**BLANDAIR REGIONAL PARK - PHASE 1 BUILDING CONTRACT**

Project: Blandair Park - Phase 1

1 SECTION  
 S2.5 1/2" = 1'-0"

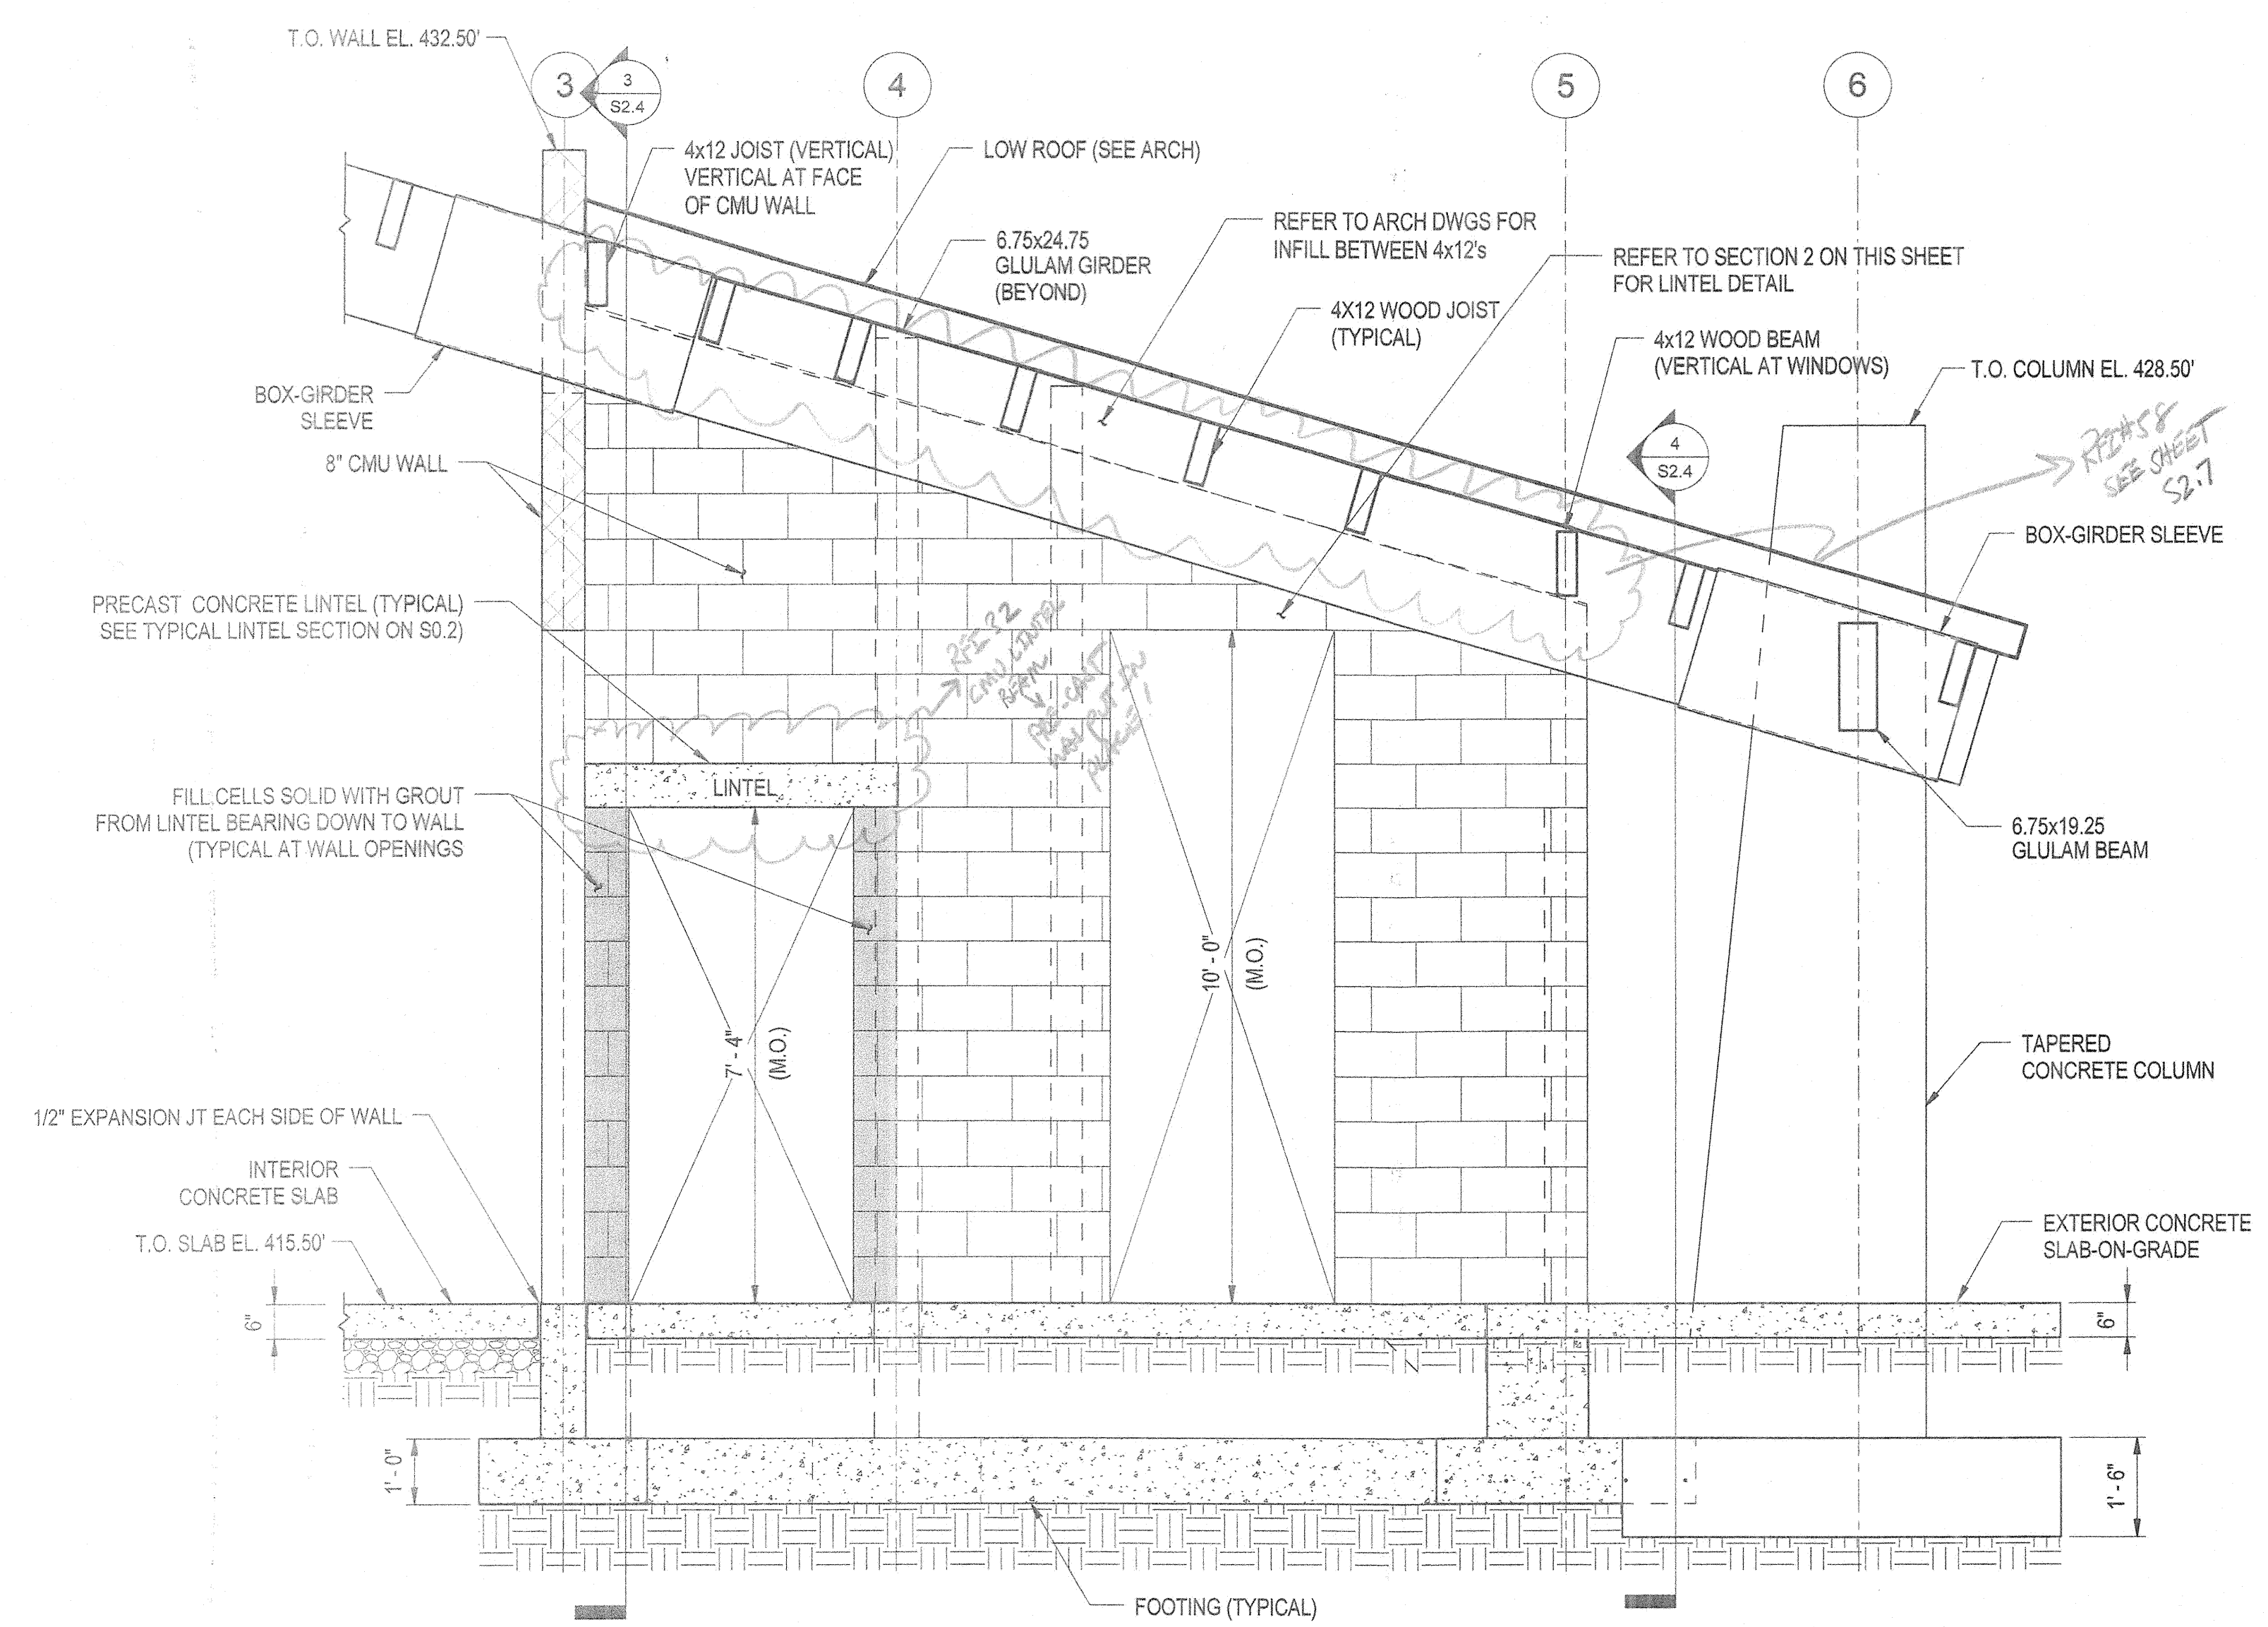
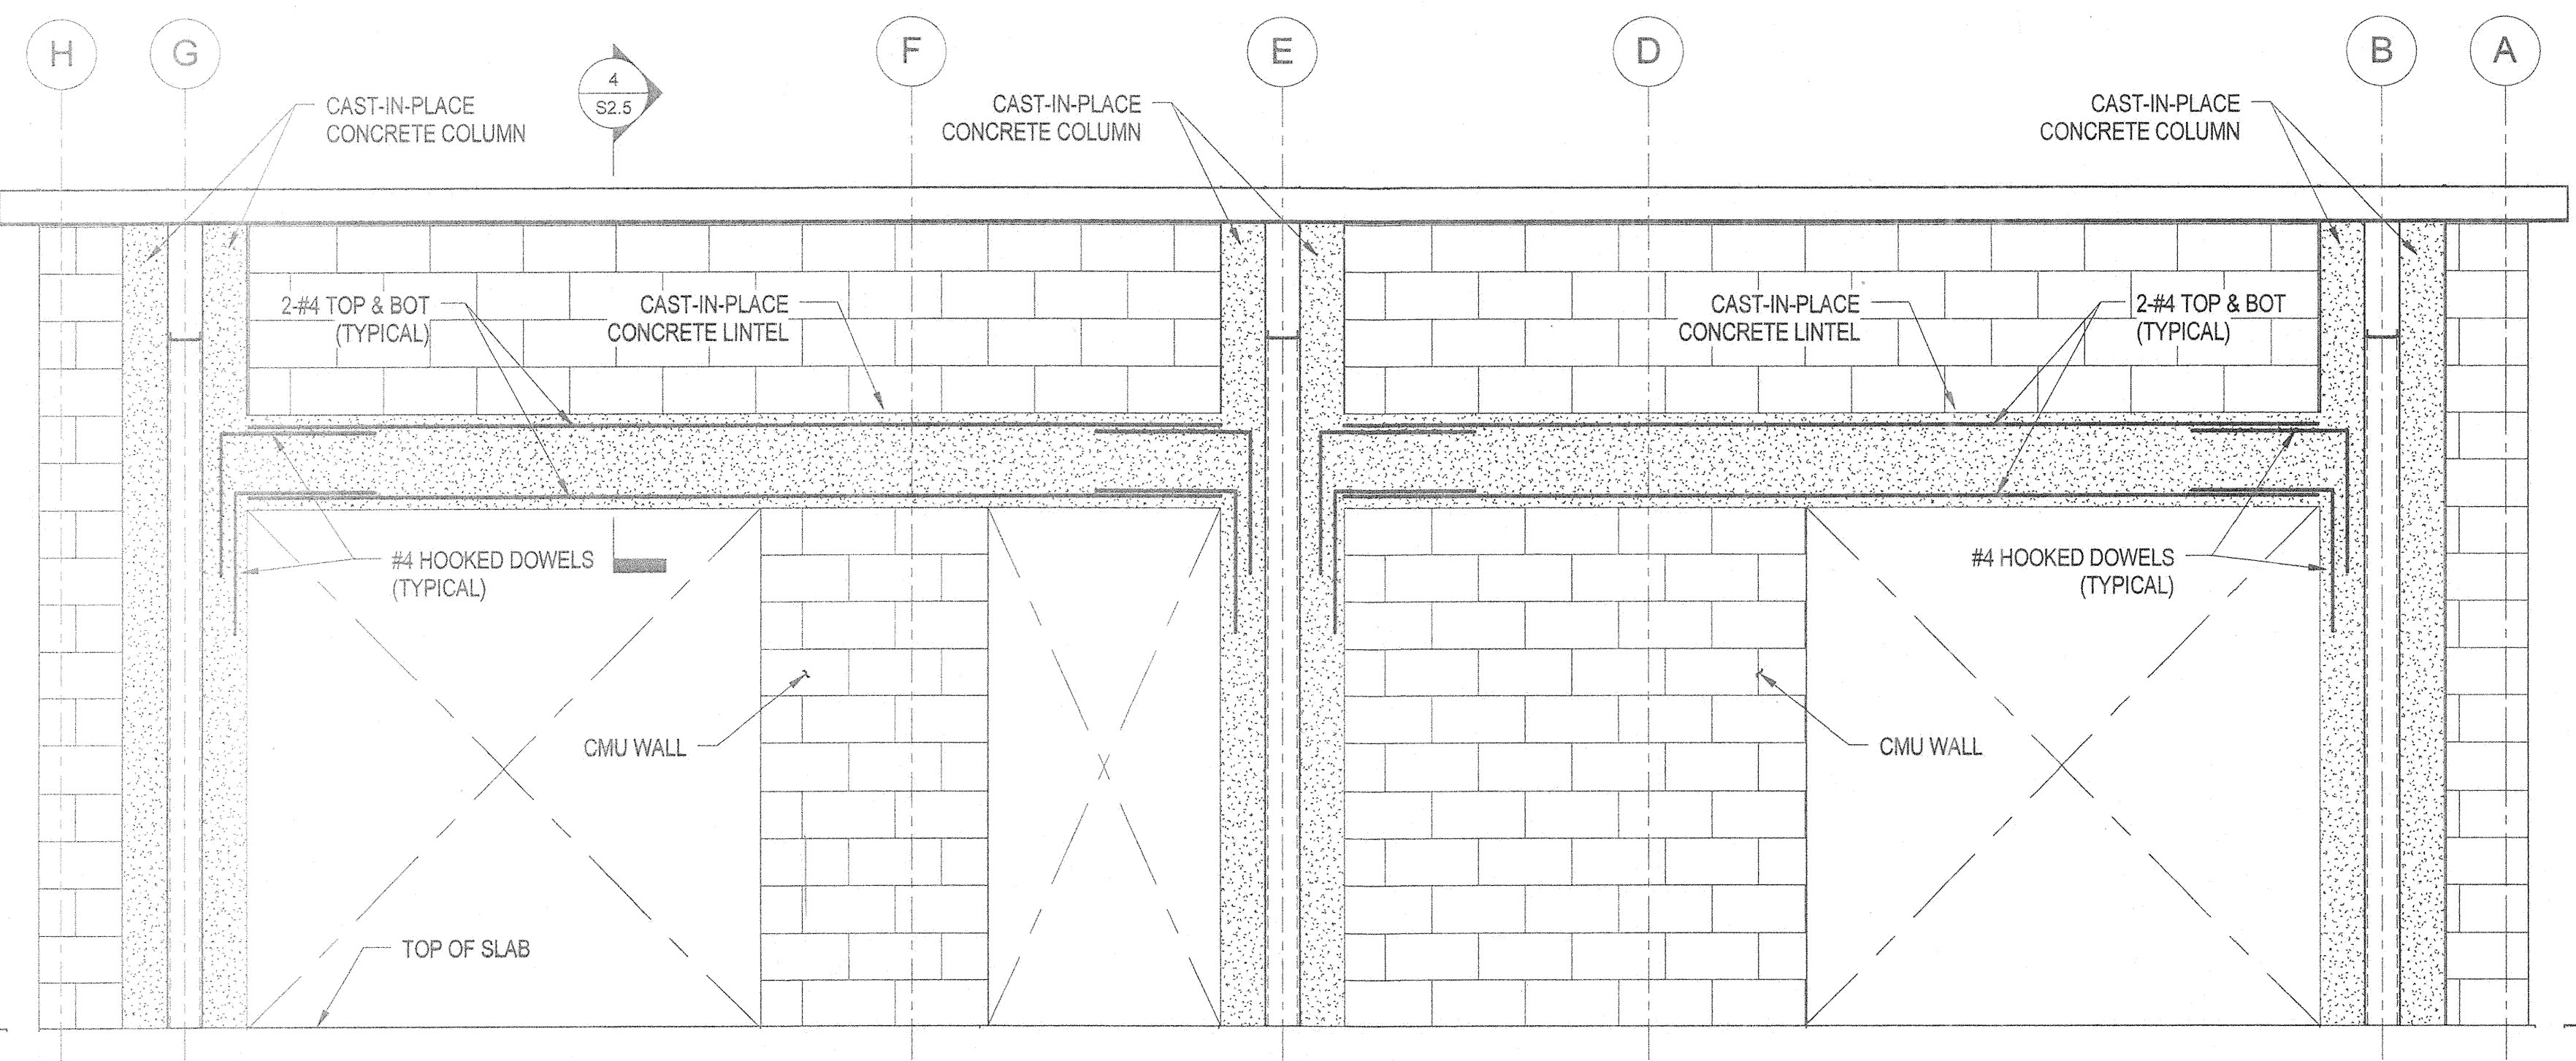
Detail 1/S2.5 shows are precast lintel at door openings. Can we use a CMU bond beam in lieu of precast lintels for these locations?

It is acceptable to use a CMU lintel beam in lieu of the precast lintel over the door shown in detail 1/S2.5. The lintel beam shall consist of 1 course of standard 8" lintel blocks filled with grout and with (1) #5 bar placed in the bottom of the lintel.

1 FOUNDATION EL CONDUIT PENETRATIONS  
SSK-1 1/4" = 1'-0"

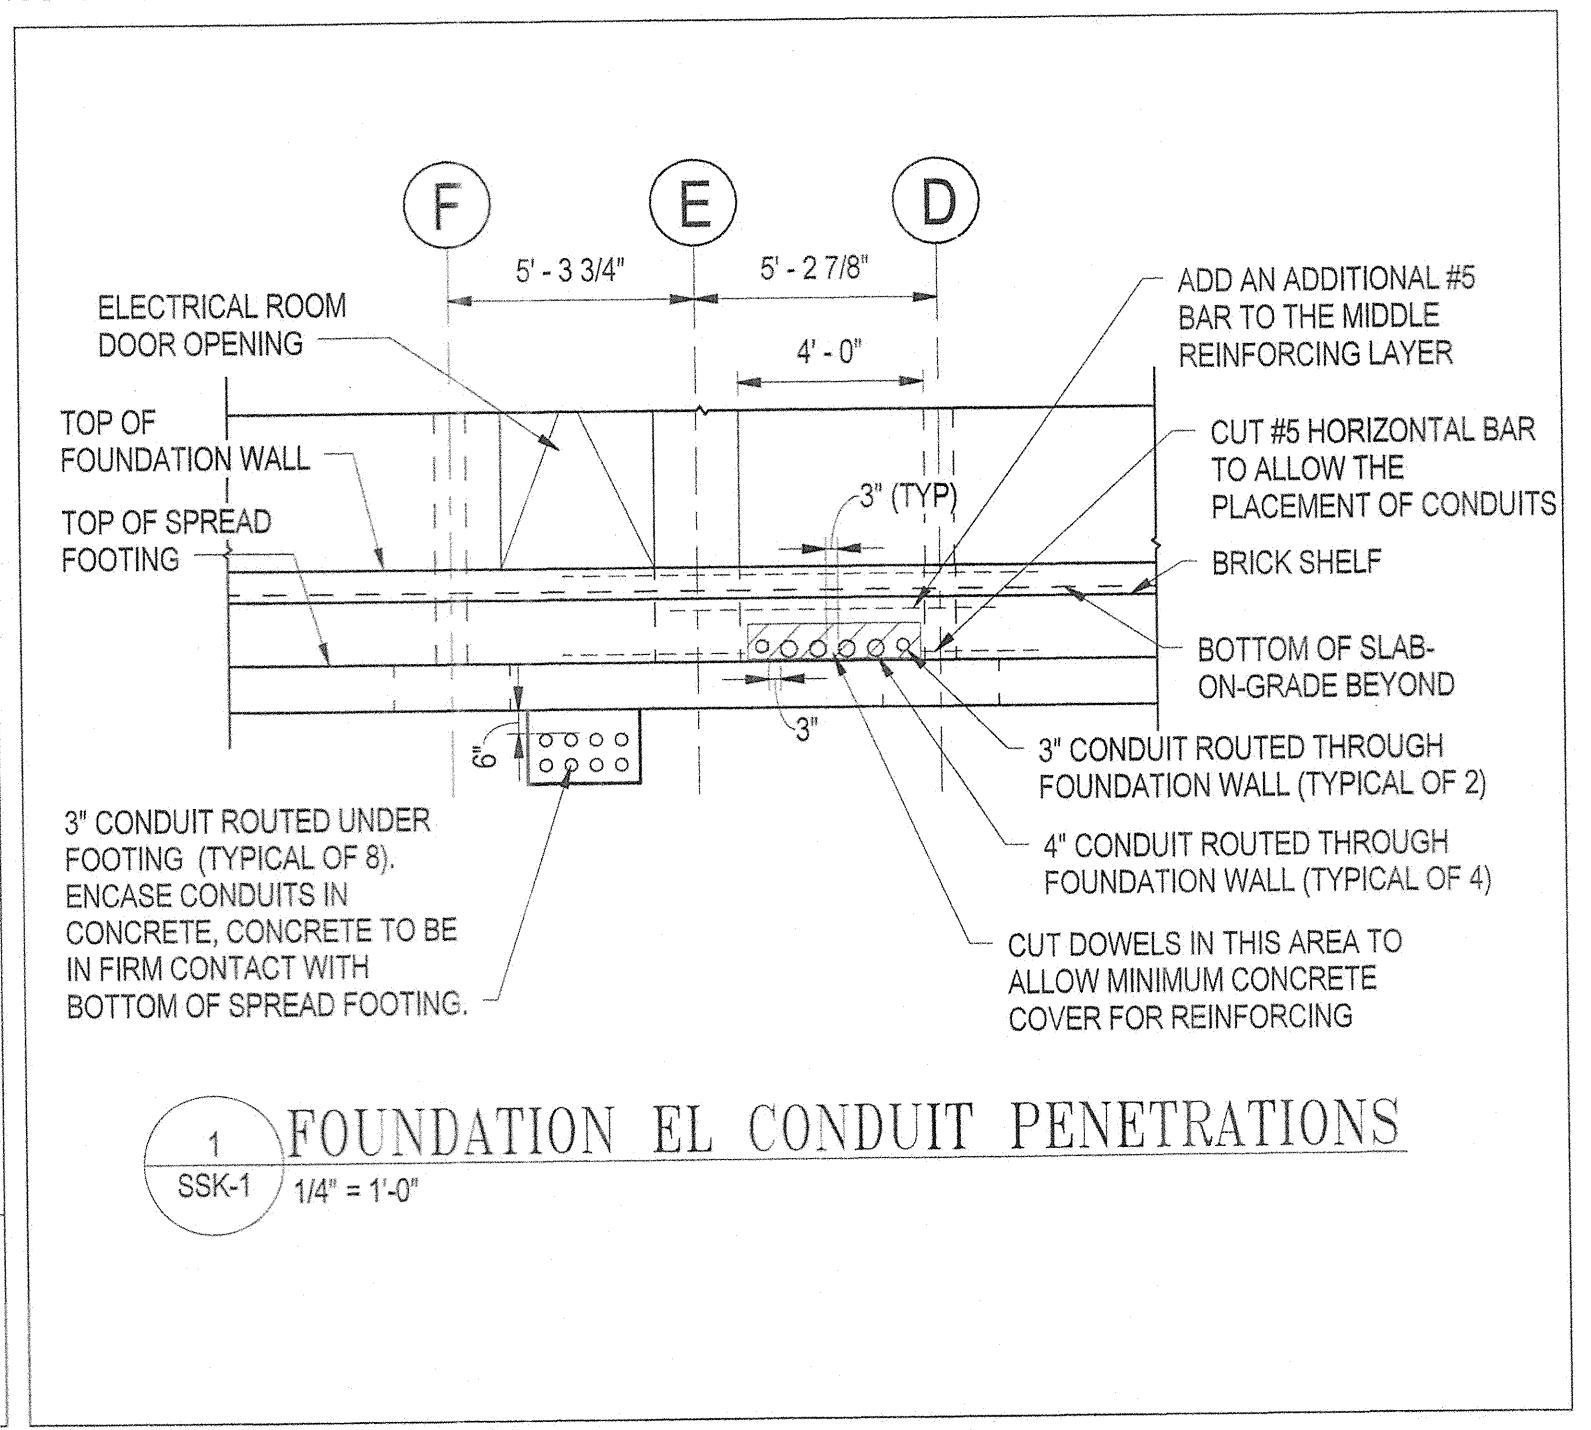
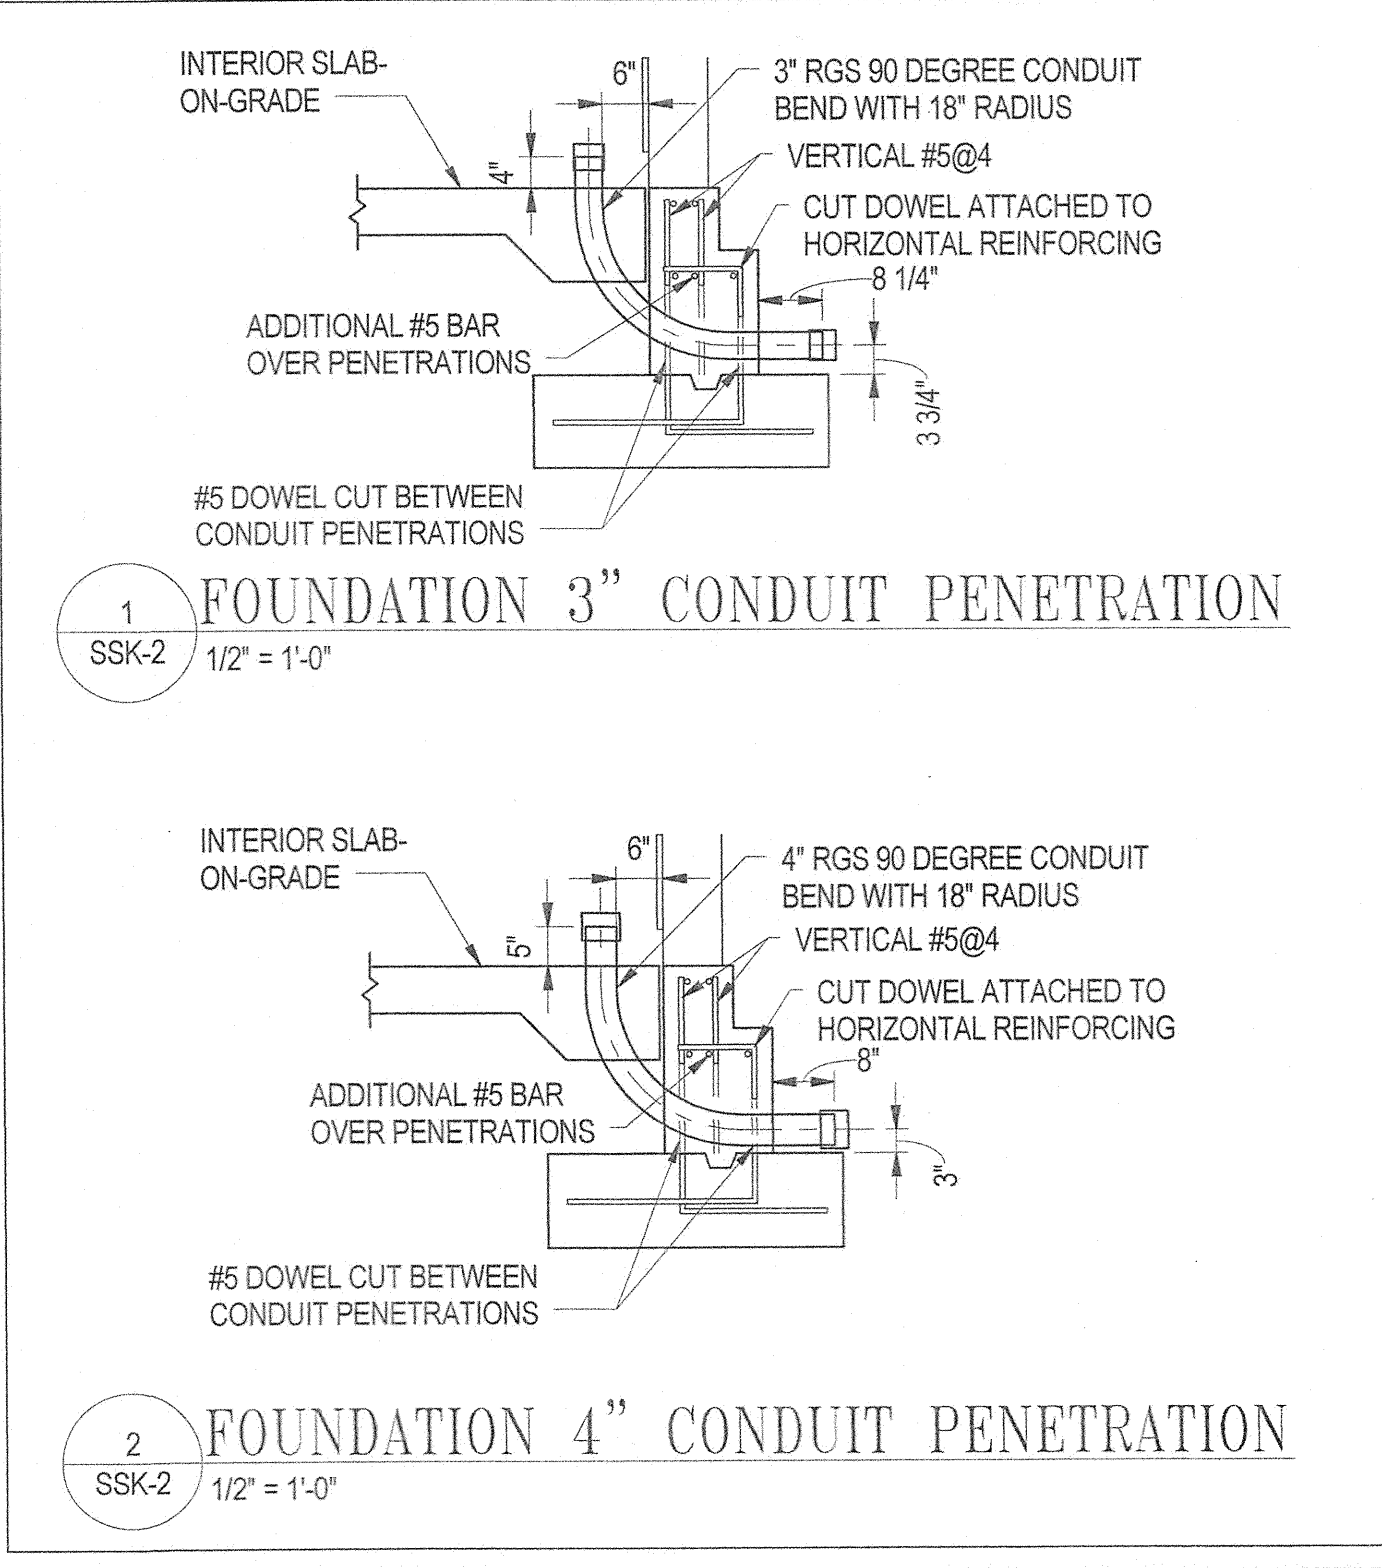
SEE RFI#18 SKETCH ESK-02 FOR  
LOCATIONS OF NEW CONDUIT  
PENETRATIONS
